1 Products affected

| Product Change Notification | | | | | PCN FUL Change of material | | |
| owner | creation date | release date | released by | change order | rev | page | D10-078-707 |

| Current plastic material | | New plastic material | |
|---|--|---|---|
| Current product appearance | | New product appearance | |

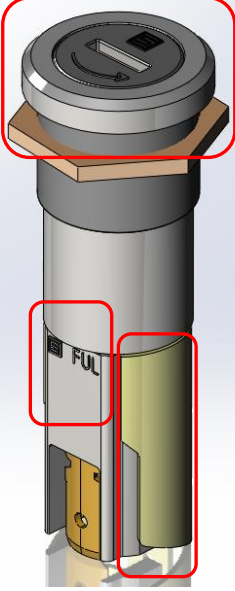
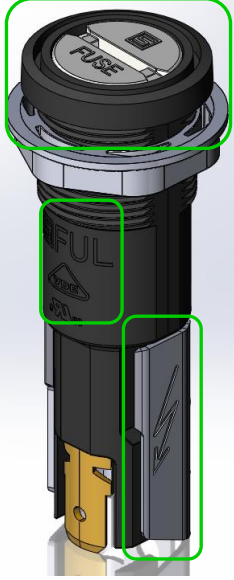
| Current plastic material | | New plastic material | |
| Thermoset | | Thermoplastic | |
|  |  <p>1 milled area</p> |  |  <p>3 milled areas</p> |

- New product design
- Position of product marking changed
- New design of cooling plates
- Plastic nut instead of metal nut

- Replace plastic material thermoset with thermoplastic for a more reliable moulding process
- Change to a modern design
